Calvert Cliffs Nuclear Power Plant, Units 1 and 2
Renewed Facility Operating License Nos. DPR-53 and DPR-69
NRC Docket Nos. 50-317 and 50-318

Subject: Response to Request for Additional Information
License Amendment Request to Revise Technical Specifications to Adopt
Risk Informed Completion Times TSTF-505, Revision 1, "Provide Risk-
Informed Extended Completion Times - RITSTF Initiative 4b."

**Response to Request for Additional Information
Revise Technical Specifications to Adopt Risk Informed
Completion Times TSTF-505, Revision 1, "Provide Risk-Informed
Extended Completion Times - RITSTF Initiative 4b."**

Figure 1 – Example 3-Train System Logic in the Model

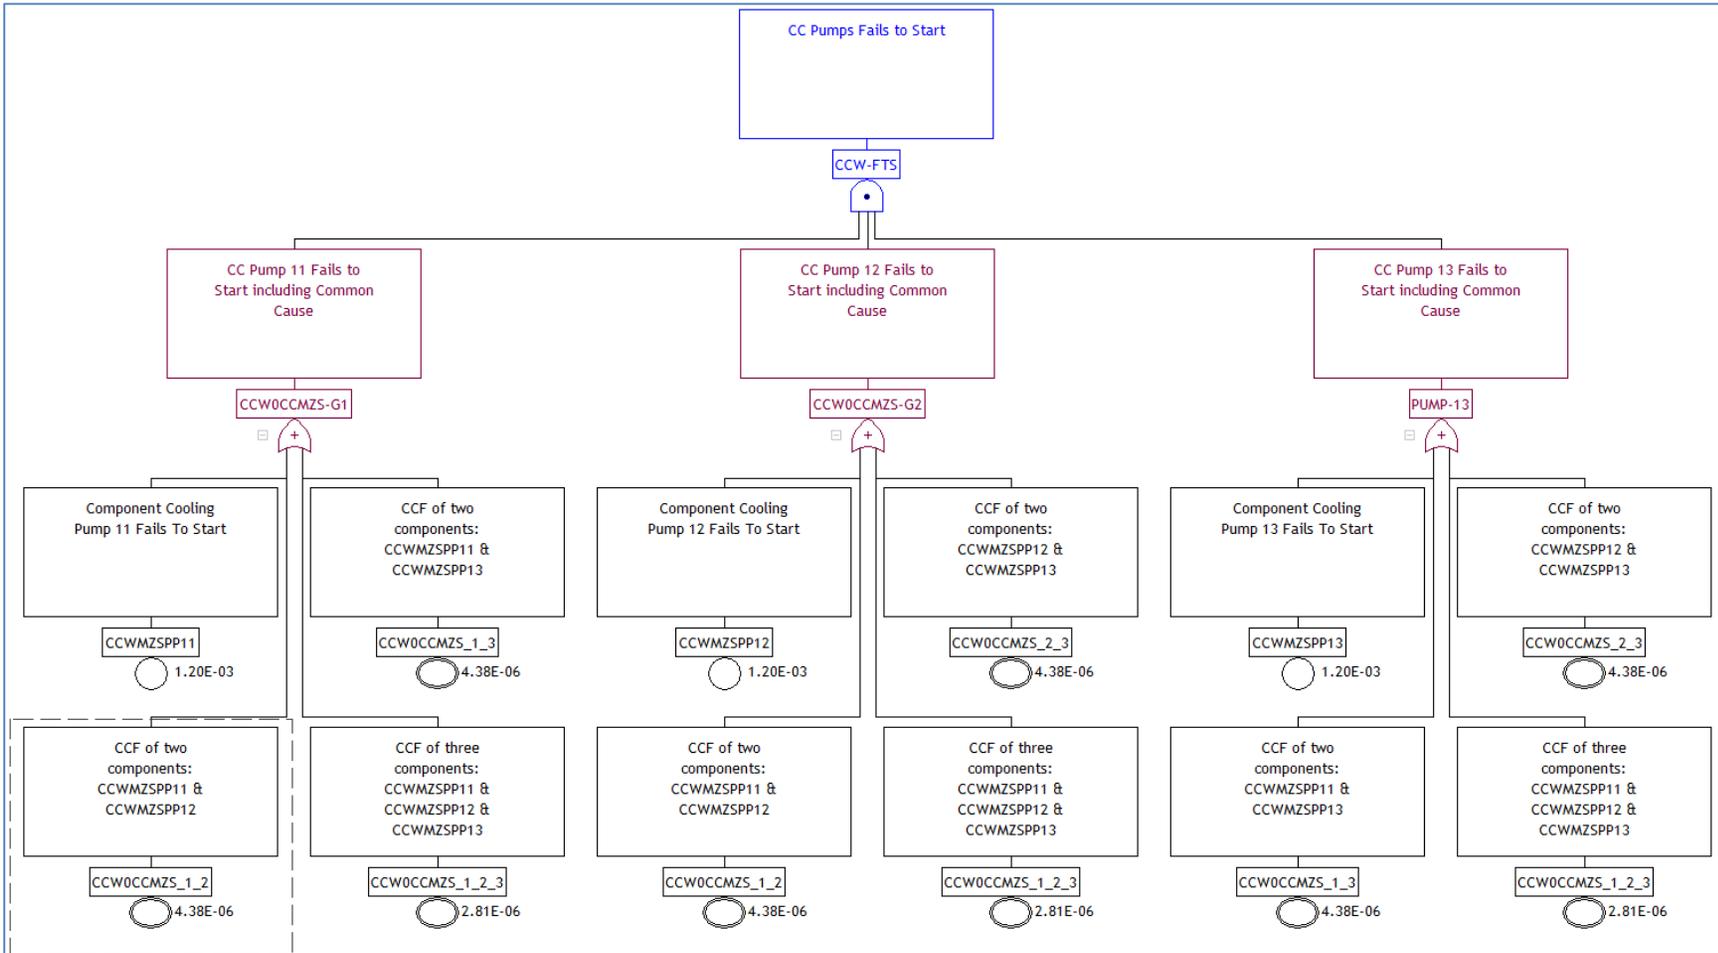
21. In RAI 10 (see letter dated November 13, 2017), the staff asked the licensee to explain how common cause failures (CCFs) are included in the PRA model and how the treatment of CCF either meets the guidance in RG 1.177 or meets the intent of this guidance when quantifying a risk-informed completion time (RICT) for preventative maintenance for components from a CCF group of three or more components. The response to the RAI states "common cause failures are modeled as separate basic events, with common cause combinations in the fault tree as different basic events." The licensee further stated that the "common cause grouping is not dynamically changed when a component is removed from service for preventative maintenance" and that this is appropriate because "the component, though not out of service for a reason subject to common cause failure, remains a participant in the common cause events for the remainder of the component operation." It is unclear how the out of service component "remains a participant in the common cause events for the remainder of the component operation" and; therefore, it is unclear how the intent of RG 1.177 is met.

Explain clearly how CCFs are modeled in the Calvert Cliffs PRA and justify why adjusting the common cause grouping is not necessary for preventative maintenance. In the explanation, include examples of fault trees for a CCF group of three components and the associated numerical results.

Figure 1 is a typical CCPRA CAFTA fault tree representation of a 3-train system where failure of 3-of-3 components fails the system top event. In this representation, the common cause event CCW0CCMZS_1_2 would fail the start function of pumps 11 and 12. Similarly, common cause event CCW0CCMZS_1_2_3 would fail all three pumps.

Using the example in Figure 1, when one pump is out of service for preventative maintenance, the system top event failure criterion is now effectively 2-of-2 components because one of the three inputs to the AND gate is made true because the pump that is out of service for maintenance cannot start. This is shown in Figures 2 and 3. Note that Figure 3 retains the CCF and independent events related to the remaining two components.
